PRODUCT IMPROVEMENT PROGRAM FOR INSPECTING AND POSSIBLY REPLACING LINERS IN CERTAIN REMAN C18 AND C32 CYLINDER PACKS IN DEALER PARTS STOCK

TEBE7405-00

SERVICE LETTER

Image1.1.1

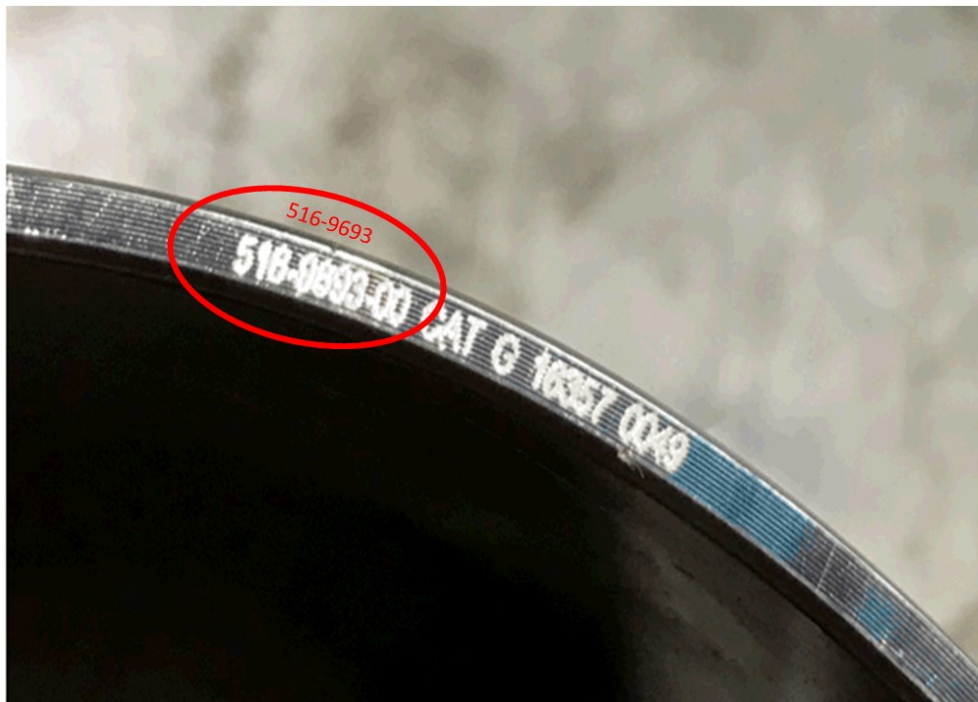
Inspect the packaging label date code. If it is from D23M03Y17P68HL (March 23, 2017) through D16M11Y17P68HL (November 16, 2017), open box and inspect liner part number. Reference Image1.1.1.

If the cylinder liner is 322-1126 or 556-0701, seal cylinder pack box and write "INSP" on the packaging label and place the cylinder pack back into dealer parts stock.

If the cylinder liner is 516-9693, replace liner with 556-0701.
